Access Compliance Report Public Rights-of-Way (Curb Ramps)

Main Street: BENNINGTON_PATH Cross Street: WELDON_HEIGHTS Location: SW

ADA ID: RPAT211104131213 Ramp Type: Type 4 - Parallel Initial Pass/Fail: Fail Overall Compliance: No Severity Score: 16

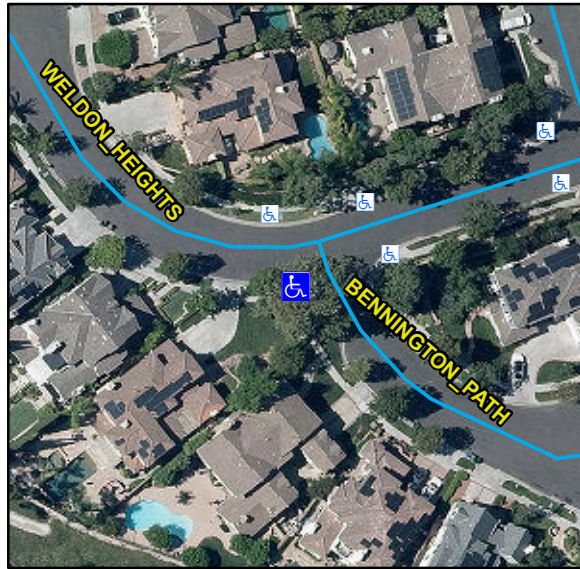
Compliance	Description	Data	Compliance	Description	Data
N/A	Ramp Length LT (in)	108	N/A	Ramp Length RT (in)	91
Yes	Ramp Width LT (in)	54	Yes	Ramp Width RT (in)	53
Yes	Ramp Run Slope LT (%)	5.7	No	Ramp Run Slope RT (%)	9.2
No	Ramp Cross Slope LT (%)	2.7	Yes	Ramp Cross Slope RT (%)	1.5
N/A	Landing Present	N/A	N/A	DWS Provided	N/A
N/A	Landing Length (in)	N/A	N/A	DWS Contrast	N/A
N/A	Landing Width (in)	N/A	N/A	DWS Length (in)	N/A
N/A	Landing Run Slope (%)	N/A	N/A	DWS Full Width	N/A
N/A	Landing Cross Slope (%)	N/A		DWS Offset Type	N/A
N/A	Landing Movement Obstructed?	N/A	N/A	DWS Offset Left (in)	N/A
	Landing Movement Type	N/A	N/A	DWS Offset Right (in)	N/A
N/A	Landing Shared	N/A			
N/A	Clear Space	Yes			
N/A	Clear Space To Crosswalk (in)	N/A			
N/A	Marked Crosswalk 1	No	N/A	Marked Crosswalk 2	No
	Crossing 1 Direction	E		Crossing 2 Direction	N
N/A	Marked Crosswalk 1 Width (in)	N/A		Marked Crosswalk 2 Width (in)	N/A

Remove & Replace Curb Ramp With Two New Directional Ramps or Equivalent.

R204.3, R304.5.3, R304.3.2, STD 1115
